## MEMORANDUM

**SUBJECT:** Committee of Adjustment Variance Application  
75 John Street, Thornhill Heritage Conservation District  
To permit a deck in the rear yard  
MNV 26 108953, A/008/26

Appendix B – Aerial View of the Existing Rear Deck

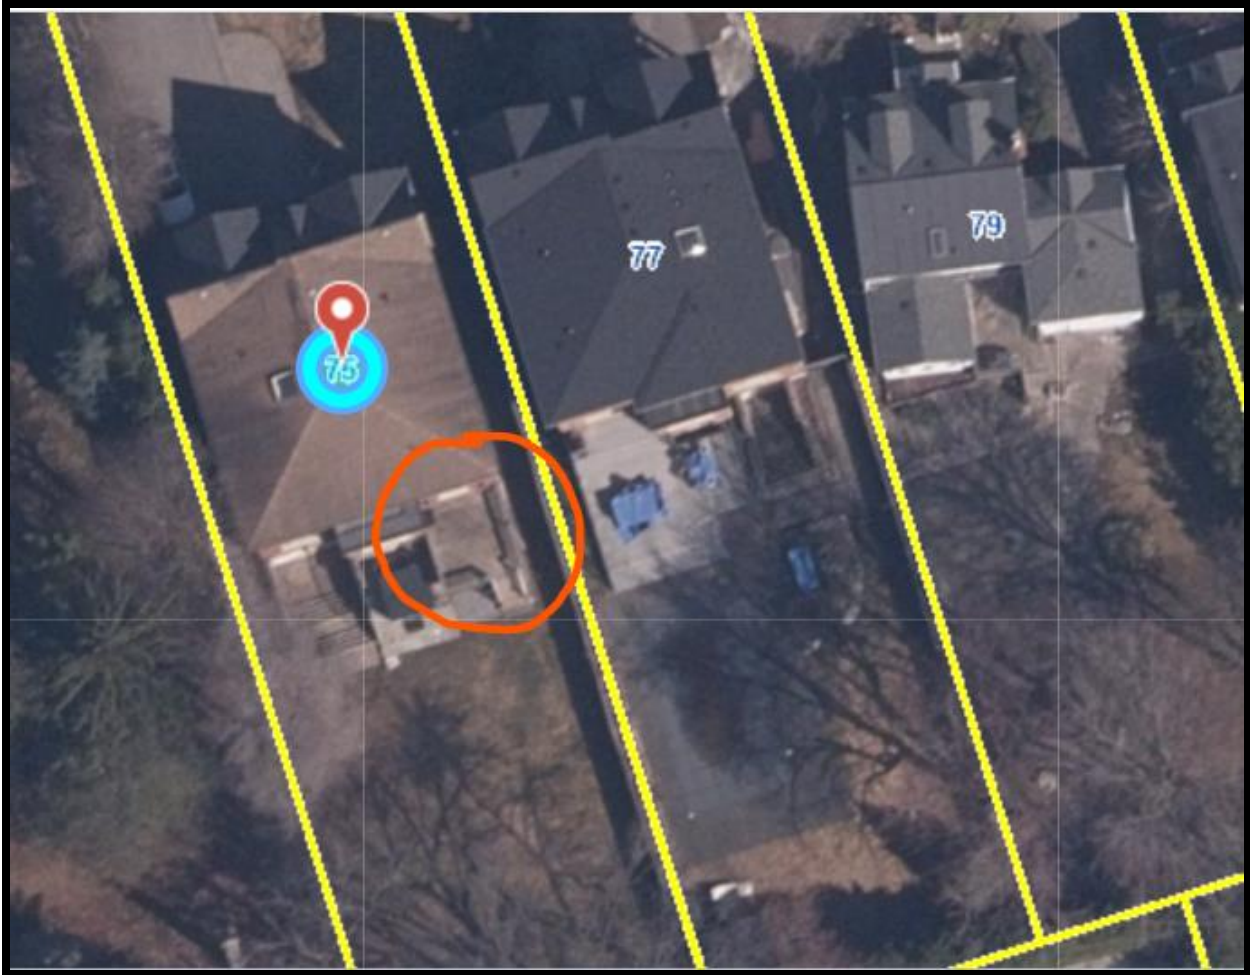
- Heritage Staff have no objection to the approval of the required variance as the proposed rear deck is accessed from the first floor of the house, is not visible from the public realm of John St. and is only 4 ft. deeper than the existing deck it proposes to replace.
- Therefore, staff recommends that Heritage Markham provide no comment on the requested variance and delegates final review of the application to the City (Heritage Section) staff.

THAT Heritage Markham has no comment from a heritage perspective on the variance application for 75 John Street to permit a rear deck to project 4.9 m into the rear yard and delegates final review of the application to the City (Heritage Section) staff.
